# Service Information Letter

Units Affected: DB37 units built between serial number 0115ET0846 (January 2015)  
and 0417ET1045 (April 2017)

## Slip Ring Modification

**Figure 1 — Cover Location**

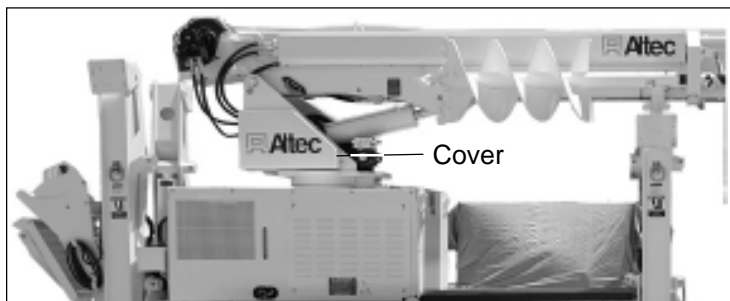
2. Remove the curbside turntable cover from the unit (refer to Figure 1).

**Figure 2 — Upper Driver Board Connections**

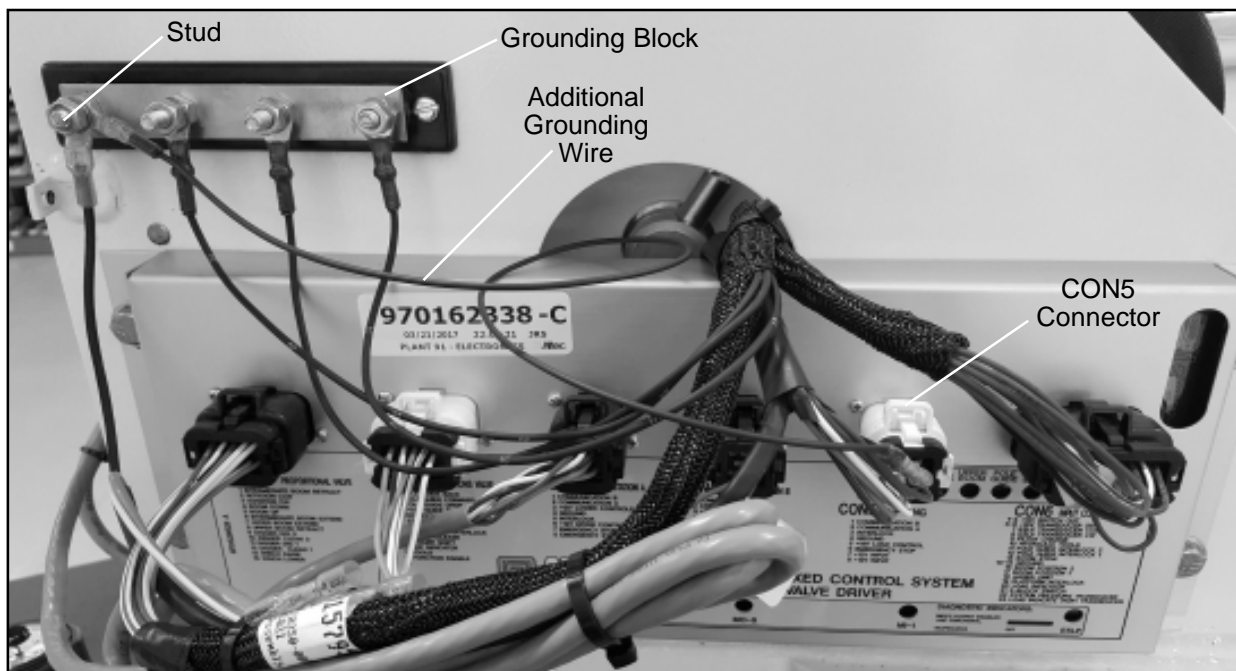
Altec discovered that the slip ring used on the DB37 to provide electrical power above rotation on the affected units is missing an internal ground wire. The missing ground wire can cause reduced reliability or can cause the HOP system to be triggered when it is not supposed to be turned on.

3. Locate the upper driver board on the side of the turntable (refer to Figure 2). Above and to the left of the driver board is the upper grounding block.

3. Remove the nut from the stud on the left end of the grounding block (refer to Figure 2).

4. Strip one end of the furnished 18 gauge wire and attach a ring terminal to that end of the wire that will fit the grounding block stud. Crimp the end of the terminal securely.

5. Attach the ring terminal to the grounding block stud. Reattach the nut and tighten securely.

6. Find the black wire in the wire harness at the CON5 connector. Cut the wire about 3 inches from the connector. Strip both ends of the cut wire.

**Figure 3 — Attaching Butt Connector**

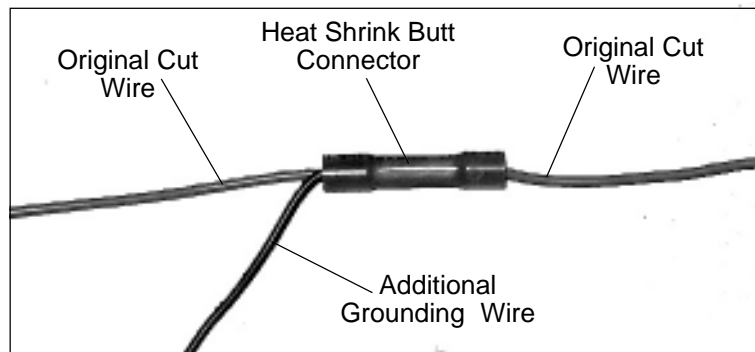
- Strip the remaining end of the furnished 18 gauge wire. Place the stripped end of the wire and one end of the wire cut and stripped in Step 5 in one end of the heat shrink butt connector (refer to Figure 3). Crimp the end of the terminal securely.

- Place the remaining end of the black wire originally connected to CON5 into the remaining end of the butt connector. Crimp the end of the terminal securely. Seal the ends of the butt connector with a heat gun.
- Secure the additional ground wire to the harness with nylon wire ties, if necessary.
- Engage the unit's hydraulic system. Operate the unit functions checking for proper operation. Make any corrections necessary.
- Reinstall the turntable cover on the unit. Retract the outriggers and return the unit to service.
